**Judson Rd. Water Infrastructure Improvement Project**  
**Solicitation Number: CO-00289-FG**  
**Job No.: 19-7002**

**ADDENDUM #2**  
**October 30, 2020**

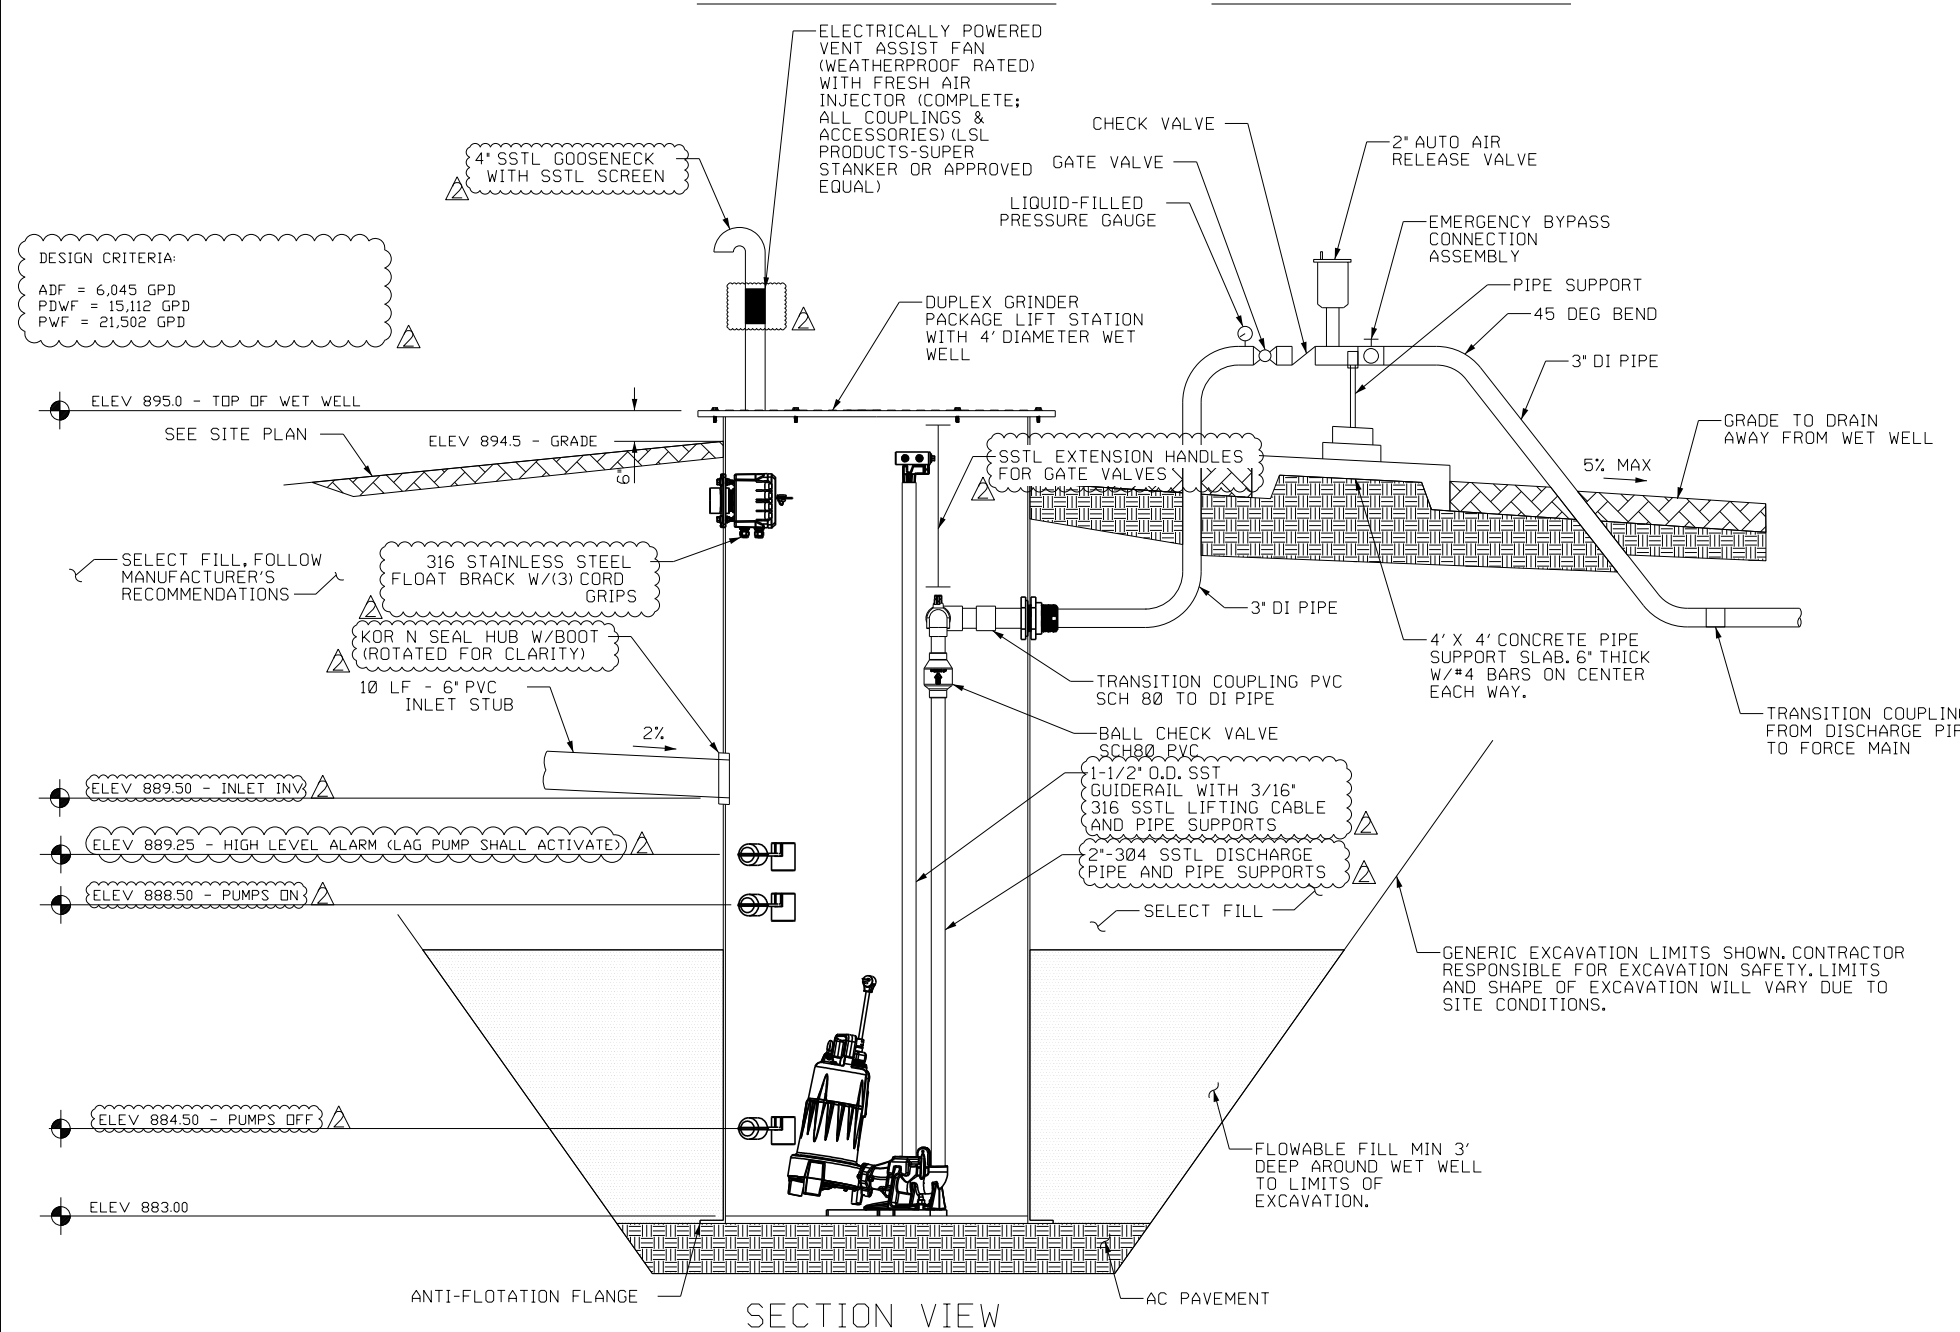
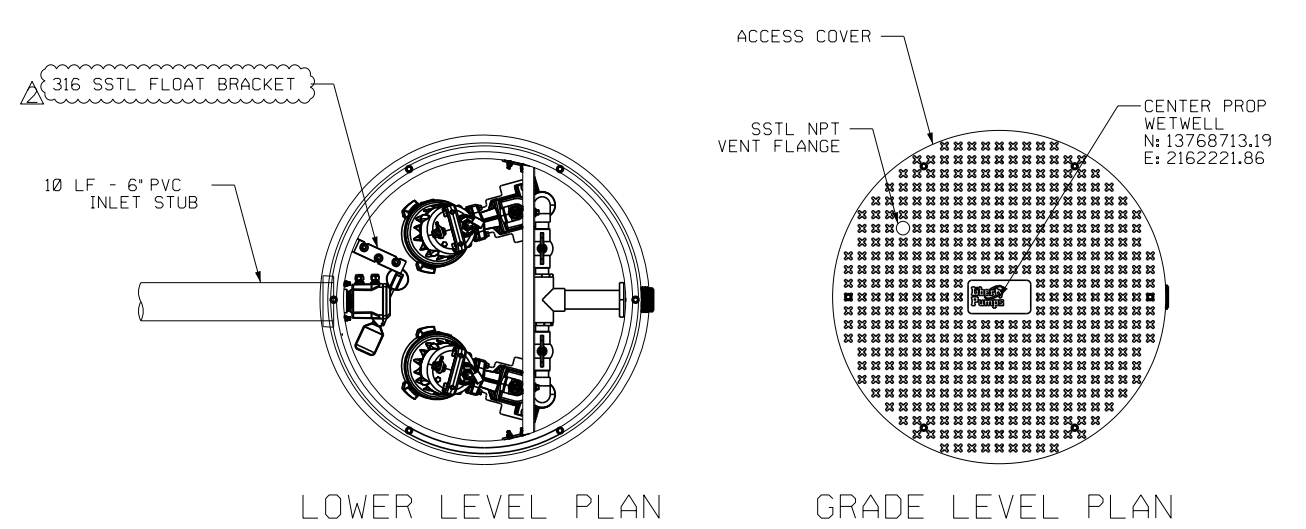
*Revised note no. 6 on plans (removed H20 rating requirement on wet well cover)*

*Revised Designed Criteria.*

*Revised Float Elevations*

*Added Electrically Power Vent Assist Fan with Air Injector to Vent Stack.*

JUDSON RD. WATER INFRASTRUCTURE IMPROVEMENTS  
**E-101**  
ENLARGED ELECTRICAL SITE PLAN

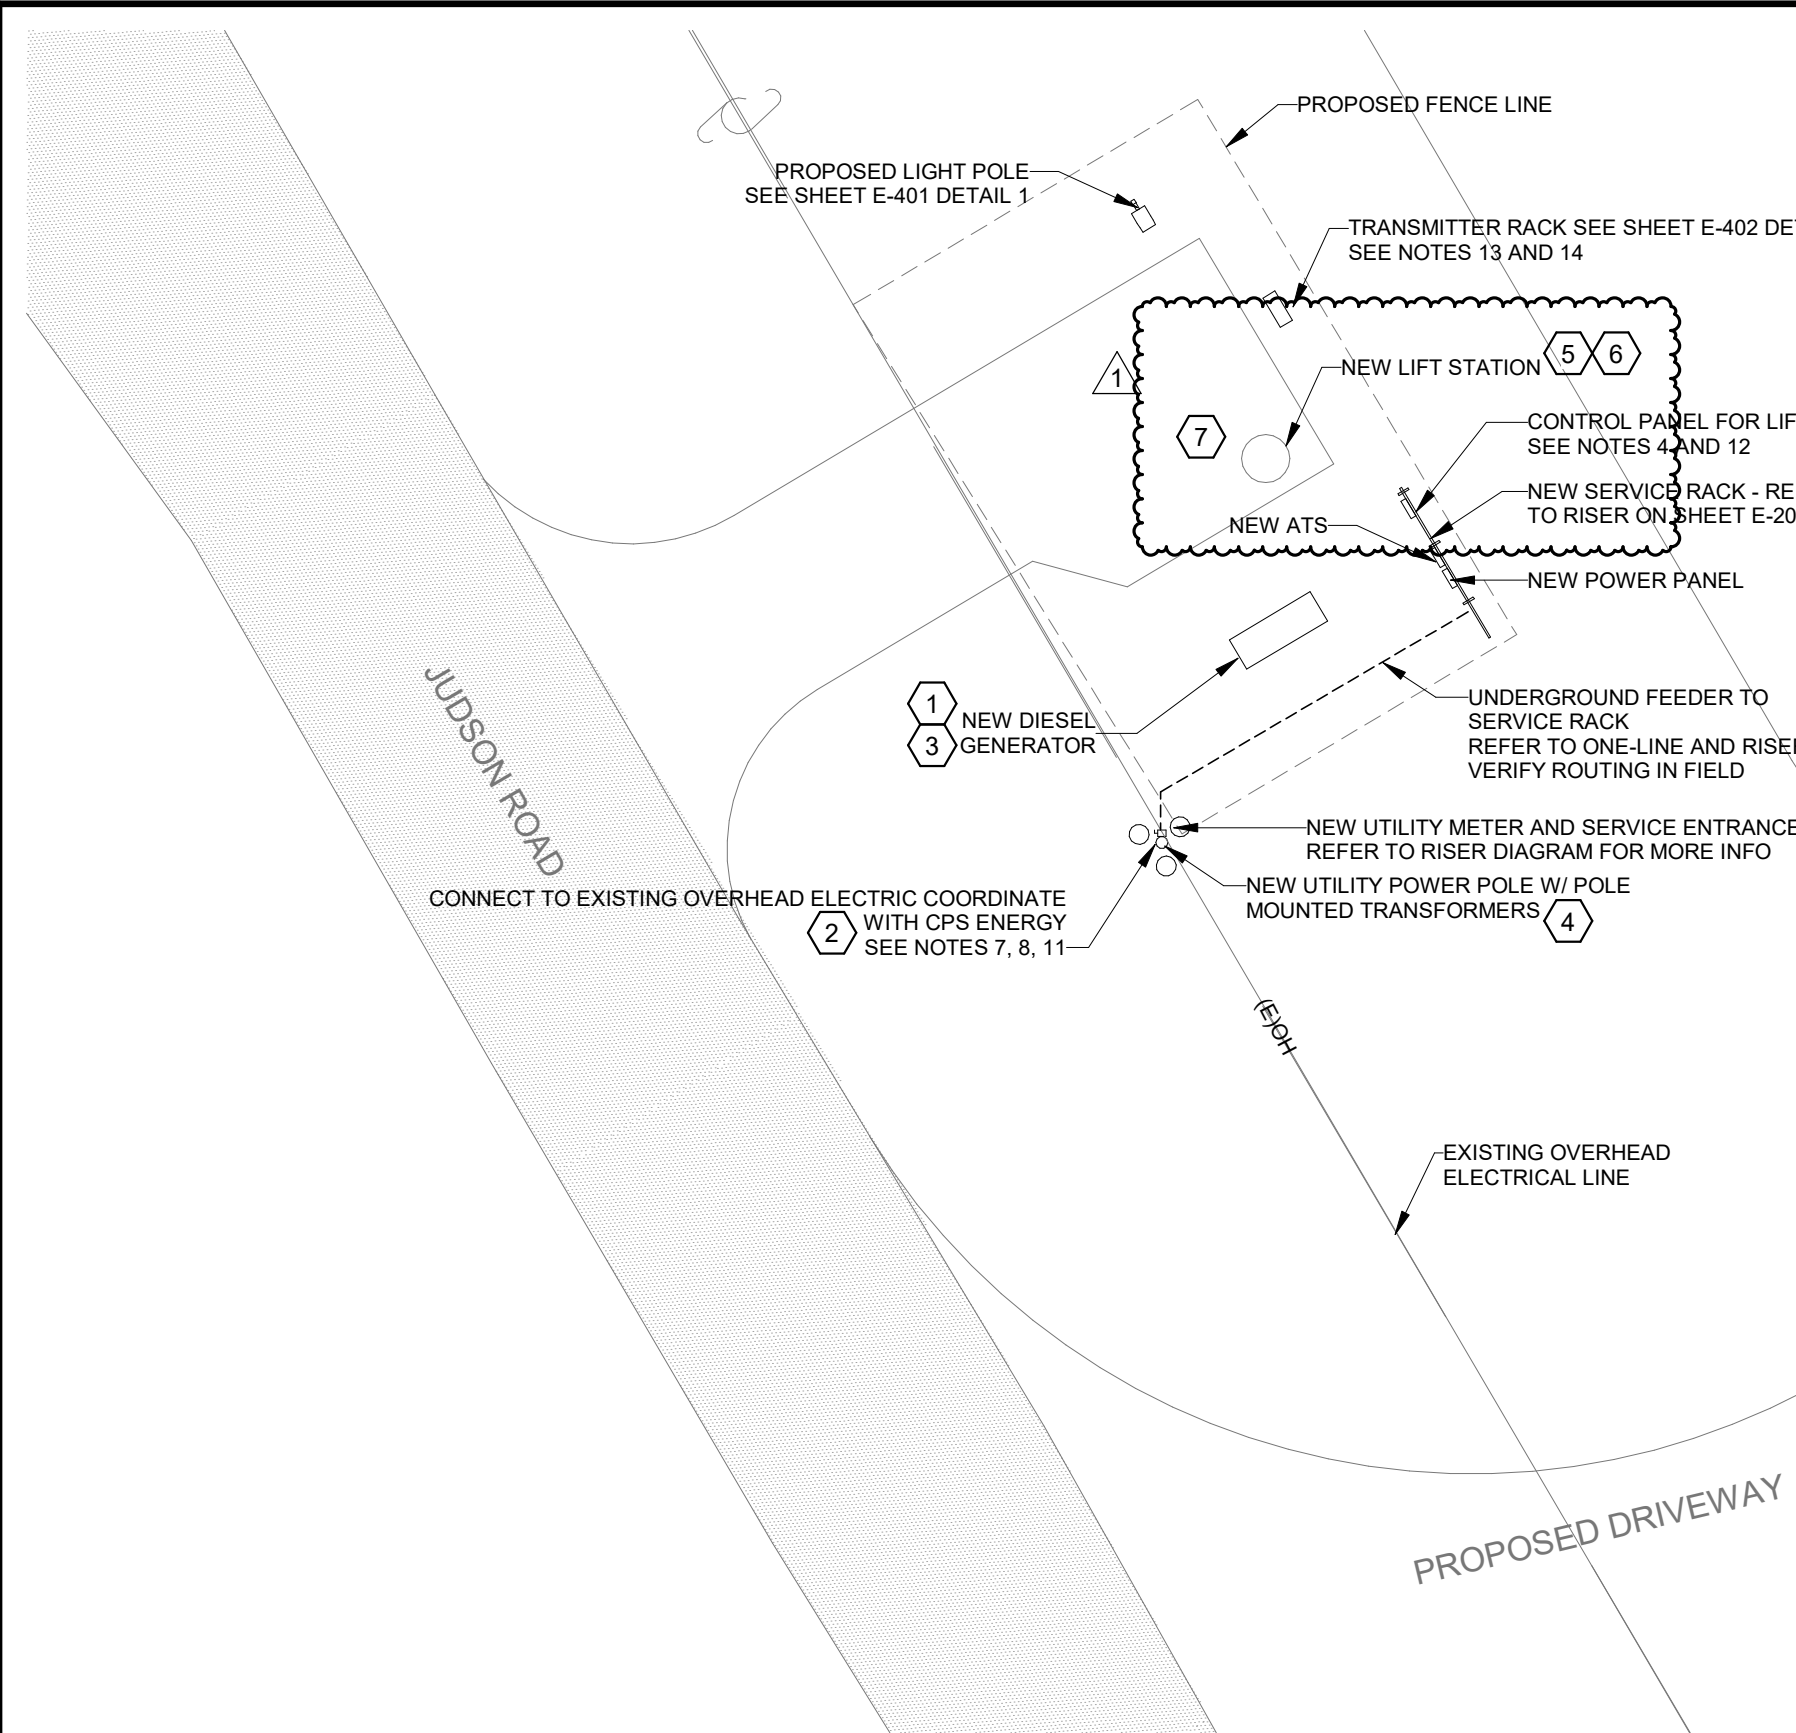
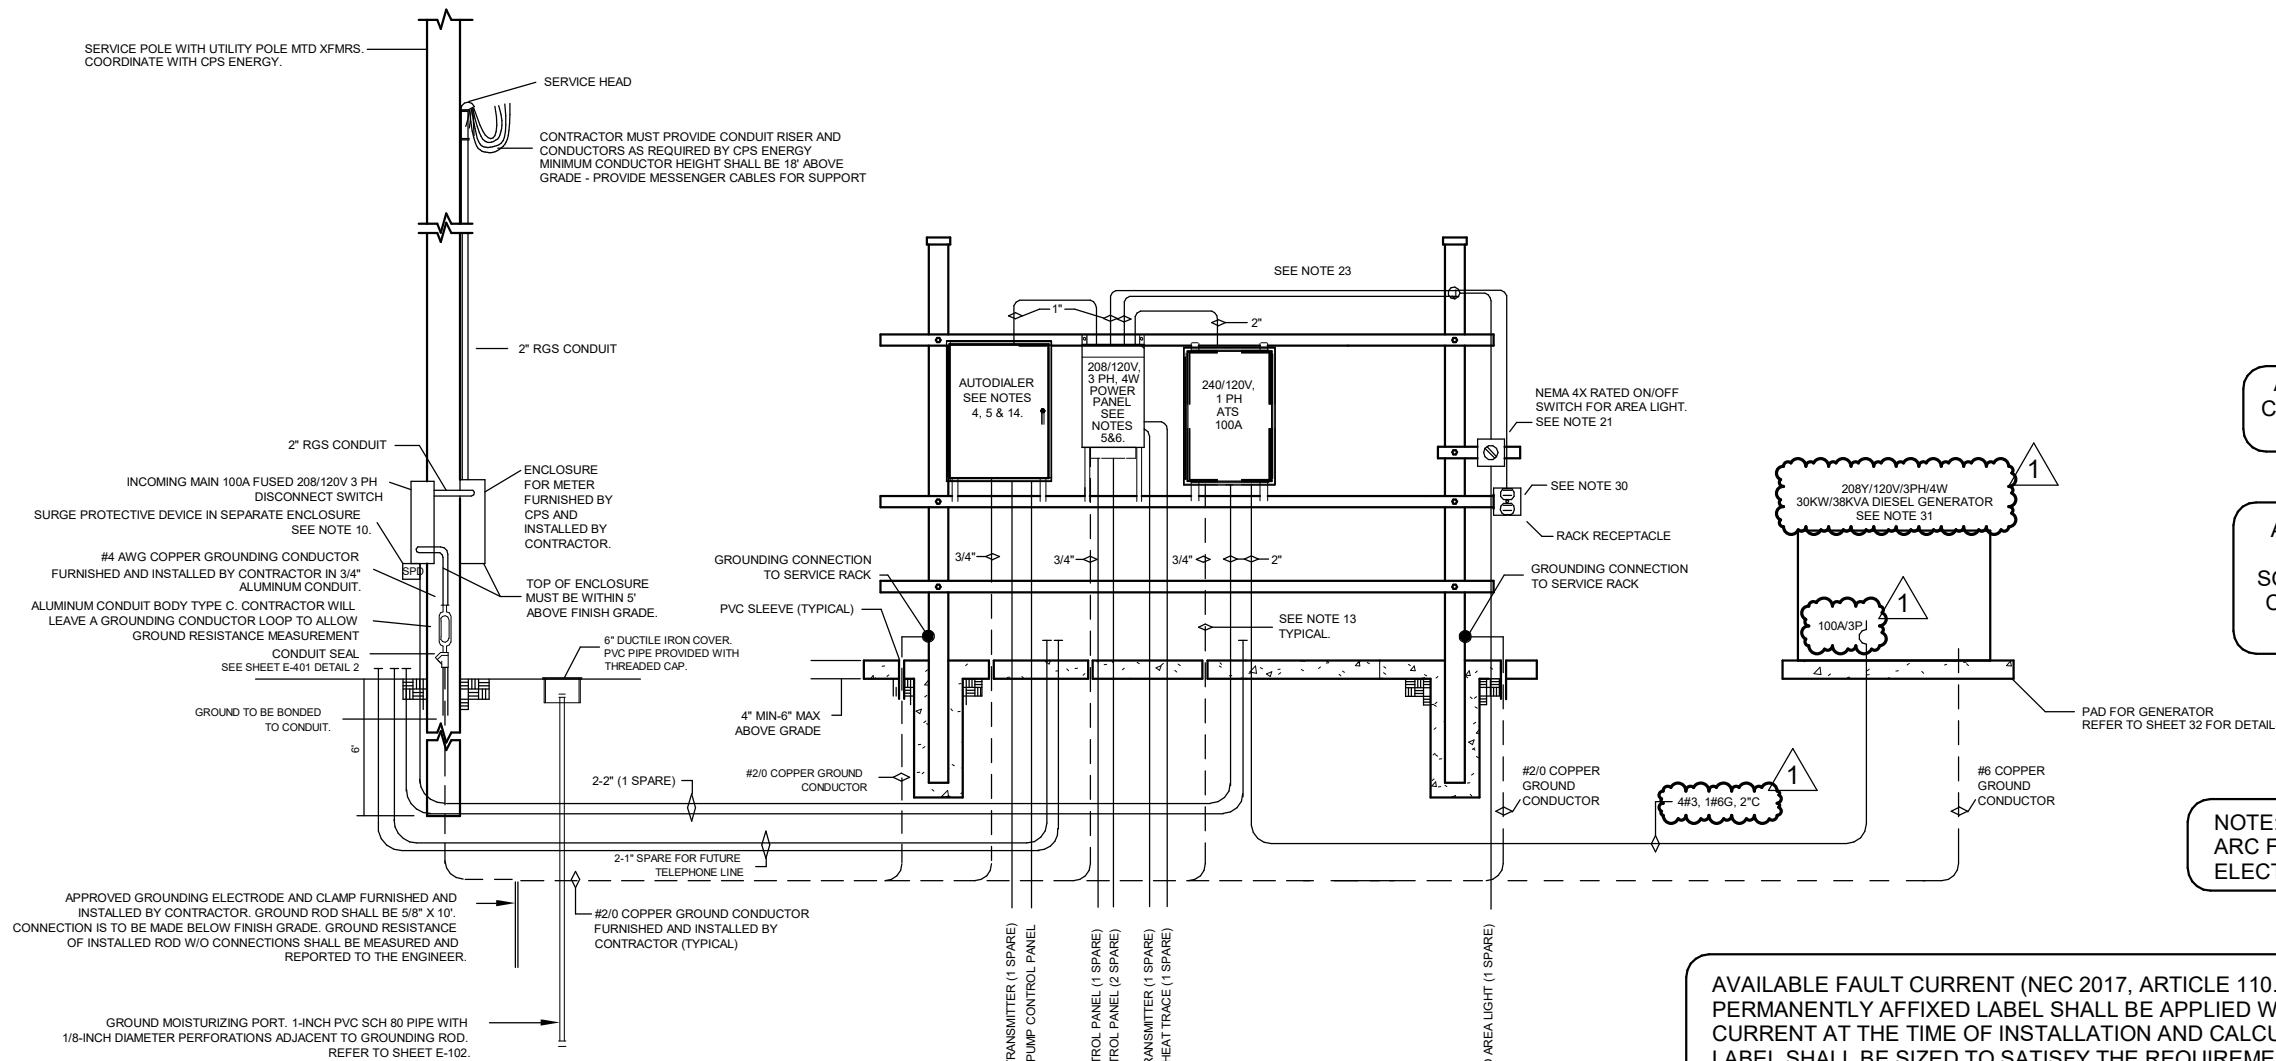
*Added power for vent pipe fan*

- 6 PROVIDE POWER TO VENT PIPE FAN. INSTALL PER MANUFACTURER'S INSTALLATION INSTRUCTIONS. PROVIDE EXPLOSION PROOF ENCLOSURES AND SEAL OFFS AS REQUIRED FOR HAZARDOUS LOCATIONS.

JUDSON RD. WATER INFRASTRUCTURE IMPROVEMENTS  
**E-200**  
 ELECTRICAL RISER DIAGRAM AND SERVICE RACK LAYOUT

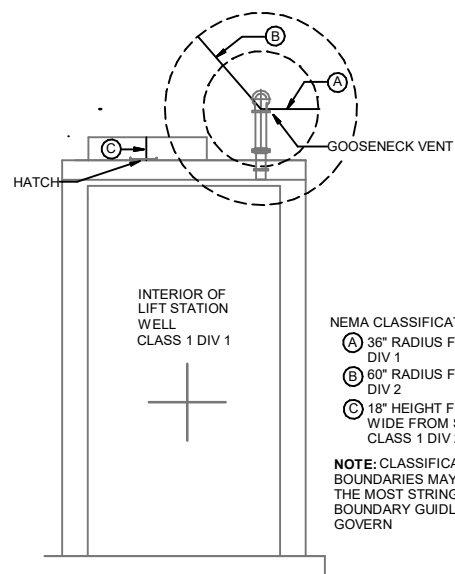
*Modified generator size and generator feeder size.*

- ALL RECEPTACLES USED ON THIS PROJECT MUST BE WEATHER PROOF WHILE "IN-USE" GFCI TYPE UNLESS NOTED OTHERWISE.
  - NEW 36KW DIESEL GENSET. REFER TO PLANS AND SPEC FOR MORE INFO. PROVIDE WITH MINIMUM 100 GALLON INTEGRAL BASE TANK.

**2** HAZARDOUS LOCATIONS DETAIL  
NTS

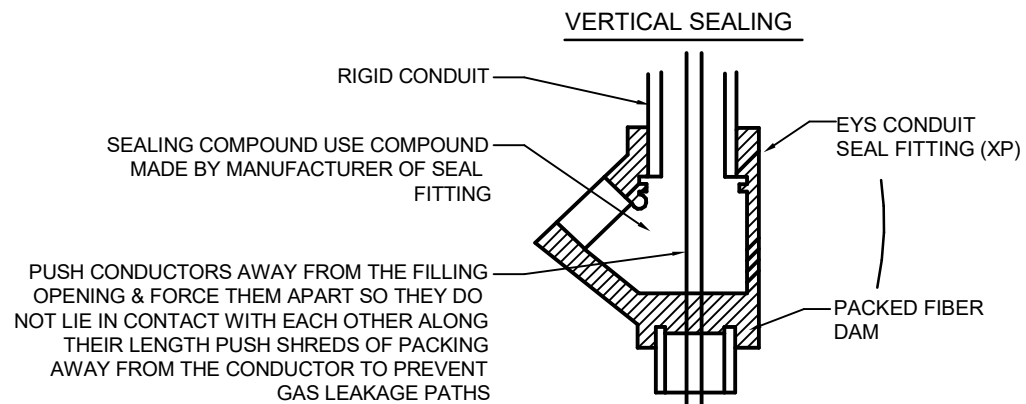
*Added details for hazardous locations and requirements.*
